Access Compliance Report

Public Rights-of-Way

(Curb Ramps)

Intersection ID: 16973	Main Street: JUDITH_CT	Cross Street: WALKER_RD	Location: NW
ADA ID: 5ABDCA03B7F6	Ramp Type: PerpDiag	Initial Pass/Fail: Fail	Overall Compliance: No
Severity Score: 10			
Codes/Mitigation Info/Possible Solution		Field Measurements/Component Compliance

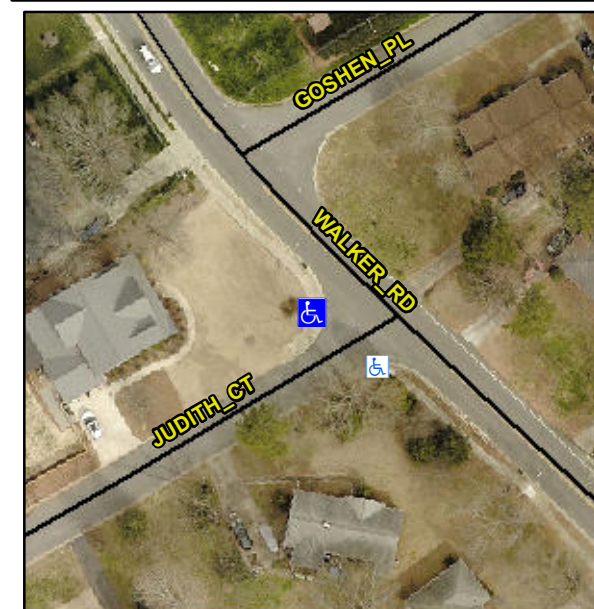
Not Found, R304.5.1, R304.5.3

Compliance	Description	Data	Compliance	Description	Data
N/A	Ramp Length (in)	27.0	Yes	Ramp Slope (%)	8.0
No	Ramp Width (in)	44.0	No	Ramp XSlope (%)	4.6
N/A	Flare Type LT	N/A	N/A	Flare Type RT	N/A
N/A	Flare Slope LT (%)	N/A	N/A	Flare Slope RT (%)	N/A
N/A	Flare Traversable LT?	N/A	N/A	Flare Traversable RT?	N/A
N/A	Landing Length (in)	N/A	N/A	DWS Provided?	N/A
N/A	Landing Width (in)	N/A	N/A	DWS Contrast?	N/A
N/A	Landing Slope (%)	N/A	N/A	DWS Length (in)	N/A
N/A	Landing X Slope (%)	N/A	N/A	DWS Full Width?	N/A
N/A	Landing Curb? (Y/N)	N/A	N/A	DWS Offset (in)	N/A
N/A	Shared Landing?	N/A			
N/A	Gutter Ponding?	N/A	N/A	Gutter Slope (%)	N/A
N/A	Gutter Lip Ht (in)	N/A	N/A	Gutter X Slope (%)	N/A
N/A	Painted X Walk1?	No	N/A	Painted X Walk2?	No
	X Walk 1 Direction	To SE		X Walk 2 Direction	To E
N/A	X Walk 1 Width (in)	N/A	N/A	X Walk 2 Width (in)	N/A
	X Walk 1 Slope (%)	1.4		X Walk 2 Slope (%)	4.6
	X Walk 1 X Slope (%)	2.3		X Walk 2 X Slope (%)	1.4

Remove & Replace Curb Ramp With Two New Directional Ramps or Equivalent.
